CLOVERLEAF SUBDIVISION
LOCATED IN NE1/4 OF SECTION 23 AND NW1/4 OF SECTION 24,
TOWNSHIP 11 SOUTH, RANGE 67 WEST OF THE 6TH P.M.,
COUNTY OF EL PASO, STATE OF COLORADO
ROADWAY PLANS

EPC STORMWATER REVIEW COMMENTS
IN ORANGE BOXES WITH BLACK TEXT

CLOVERLEAF FILING 2
EL PASO COUNTY, COLORADO
STORM SEWER AND POND PLANS

PUBLIC UTILTY PLAN

SHEET 2 OF 25
JOB NO. 25158.01

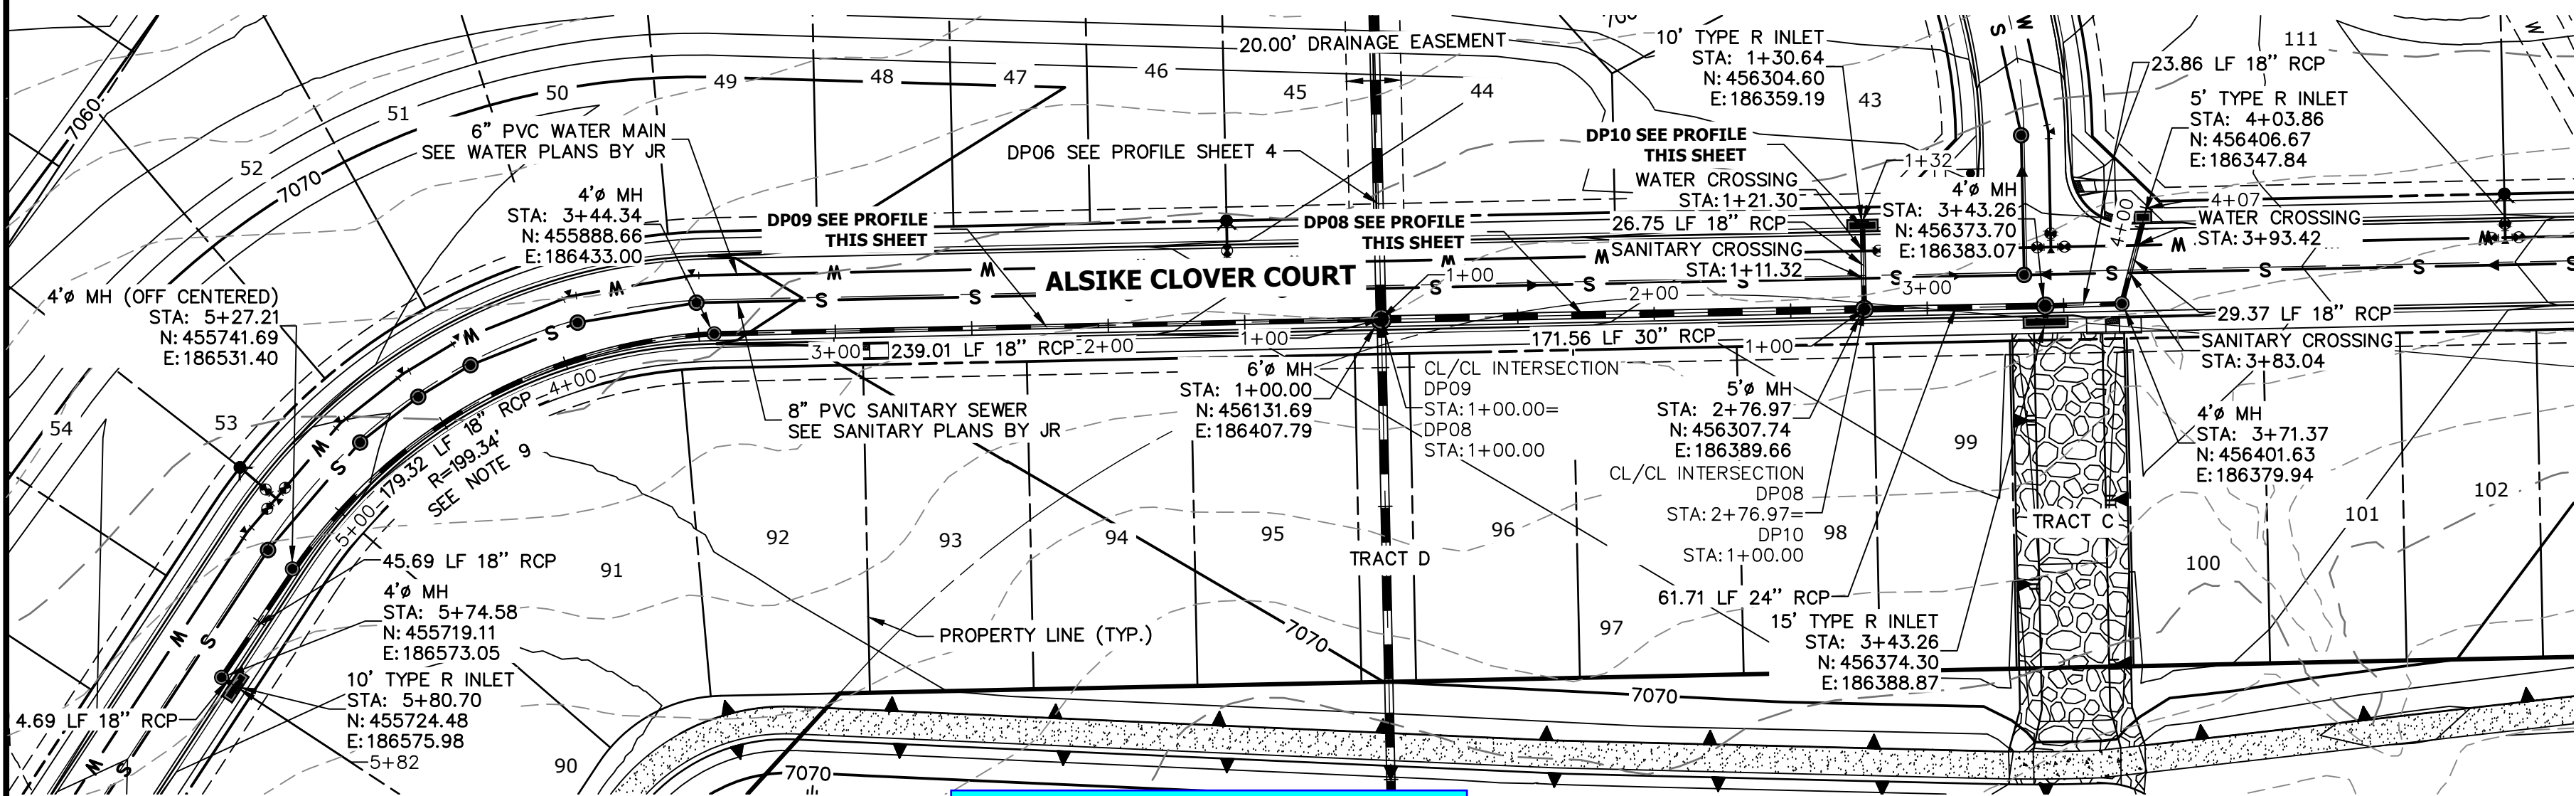
Label storm lines within the ROW as public and outside the ROW as private.
See the preliminary plans for which main is noted as public or private.
Update the financial assurance estimate form accordingly. public storm sewer is listed in Section 2 and private storm sewer is listed in section 3.

STA 1+00.00 TO 5+82.20

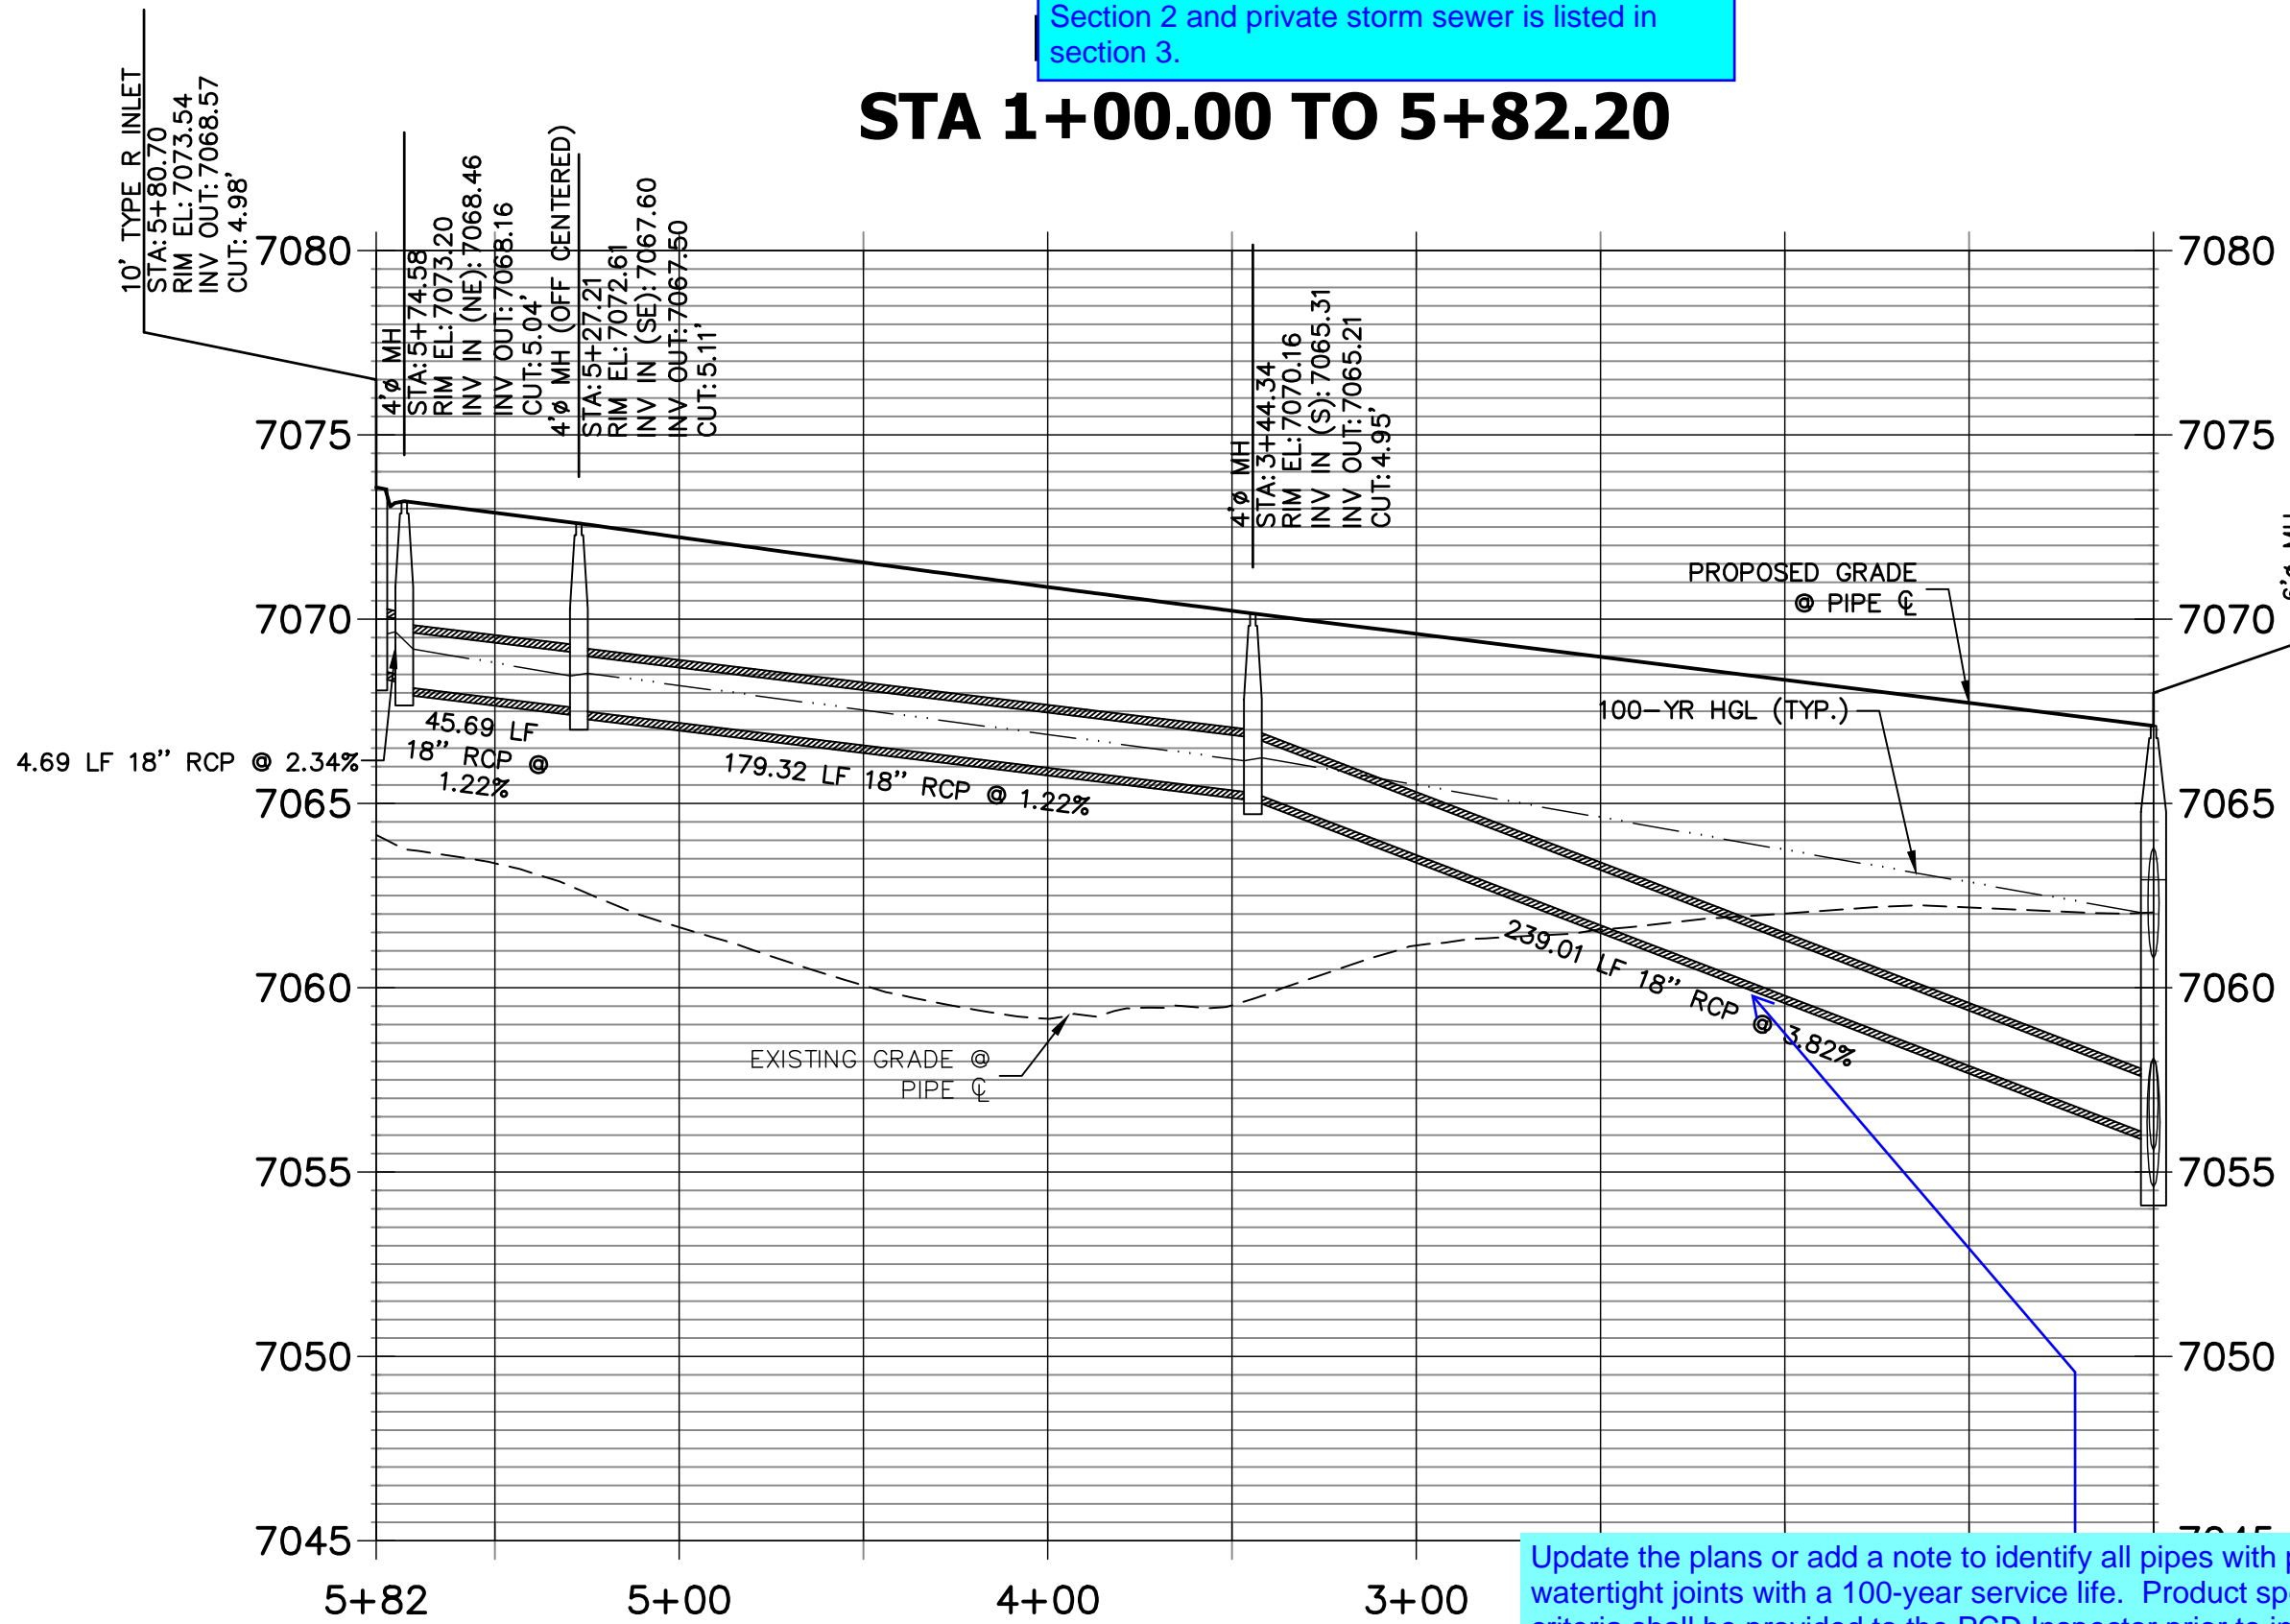
Adjust so the inside top slopes of the conduits are continuous through the manhole per ECM 3.3.1 J.2 or submit a deviation request to allow drop manholes for the ECM Administrators consideration.
Staff recommends you review the approved deviation request for Trails at Aspen Ridge, SF192 in preparing your deviation request.

Update the plans or add a note to identify all pipes with pressure head shall use watertight joints with a 100-year service life. Product specification meeting this criteria shall be provided to the PCD Inspector prior to installation.
See ECM 3.3.1 D for the specific criteria.

DP08 PROFILE
STA 1+00.00 TO 4+07.41

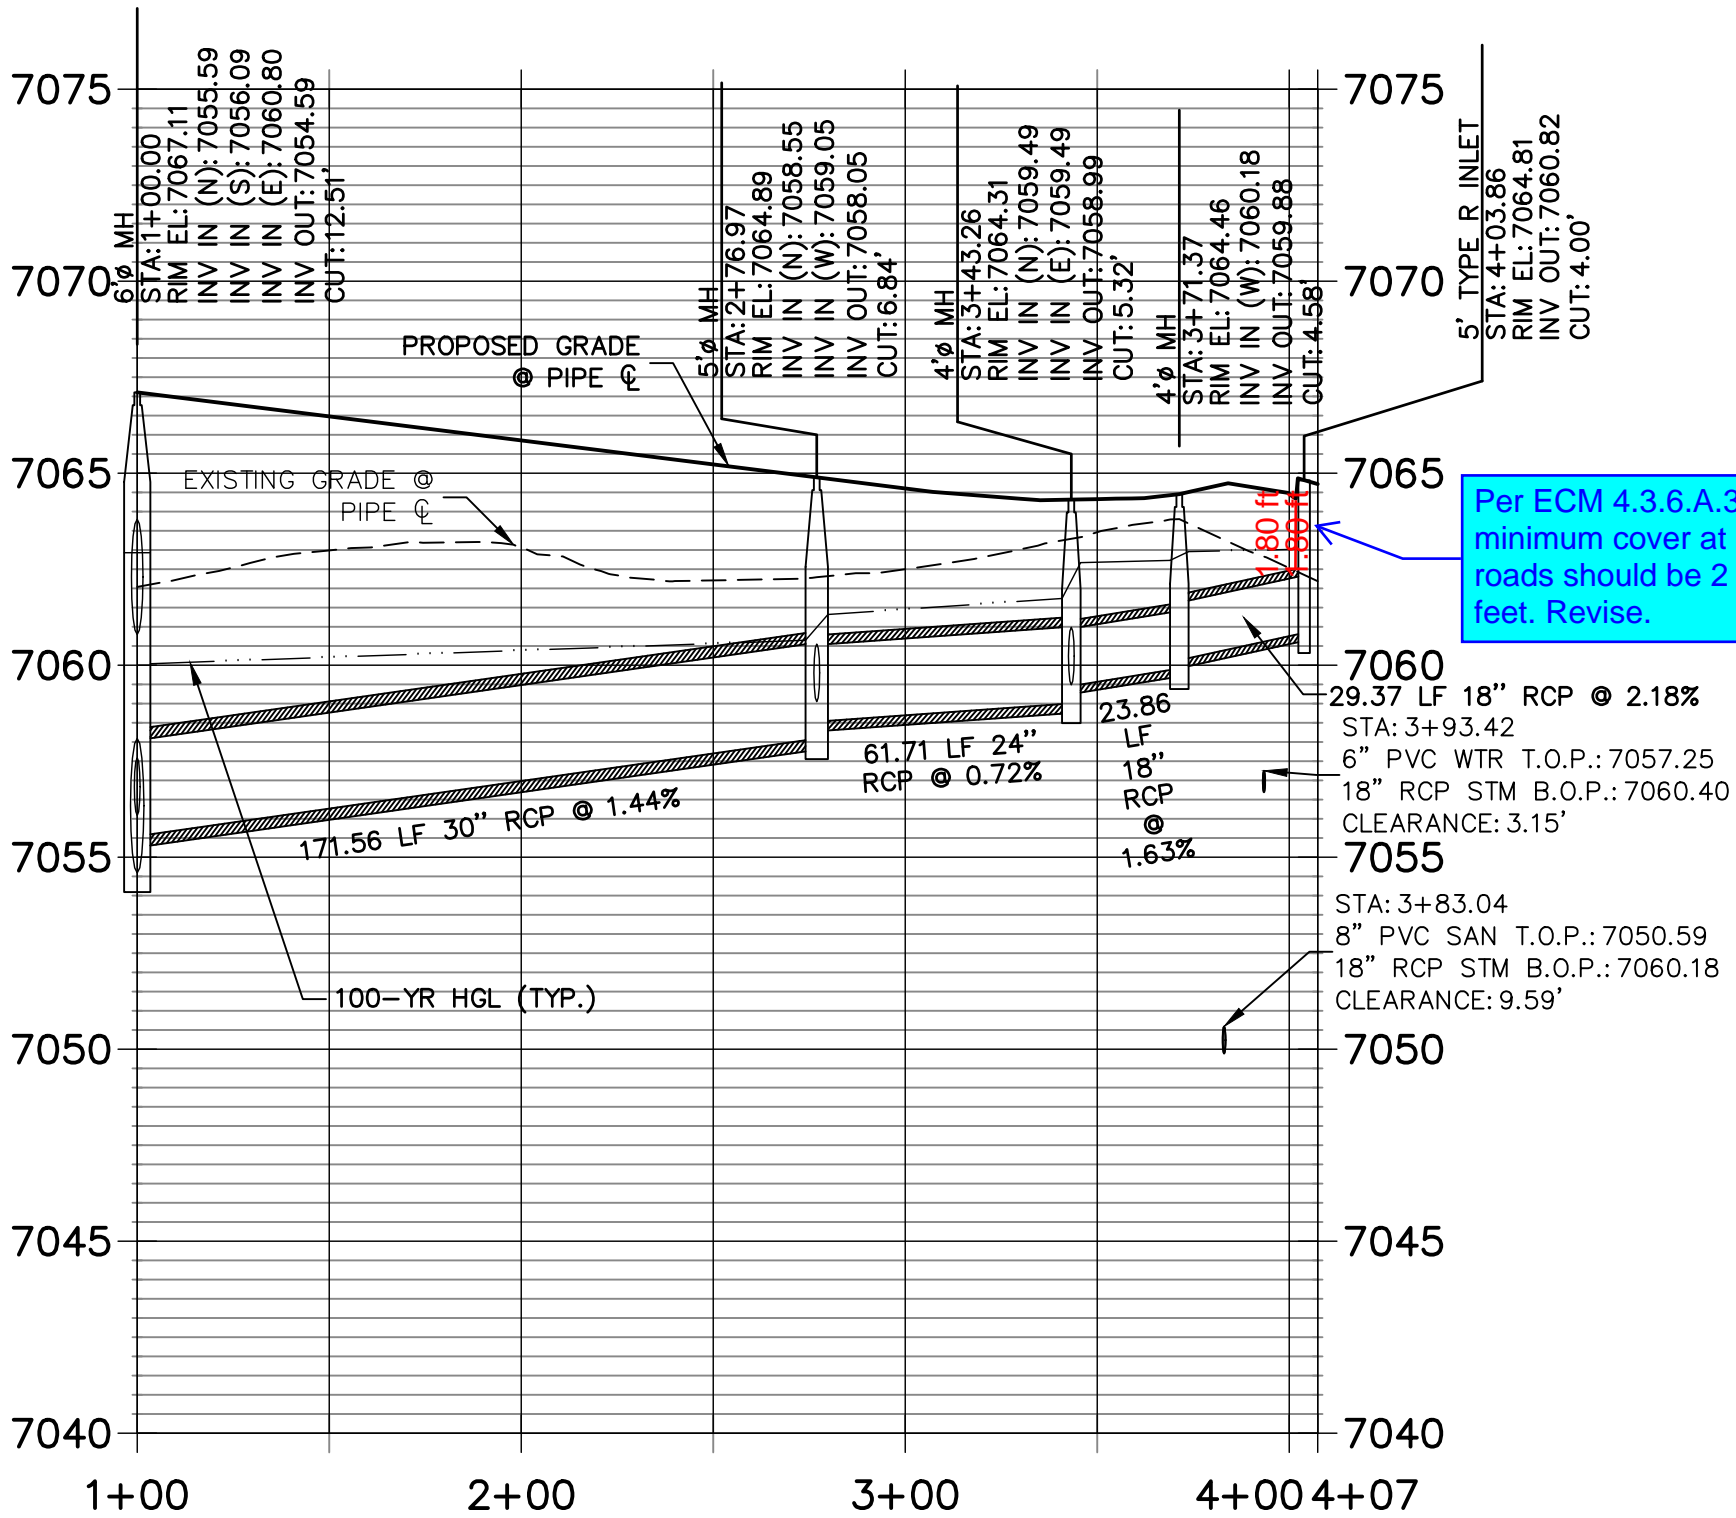
Per ECM 4.3.6.A.3, minimum cover at roads should be 2 feet. Revise.
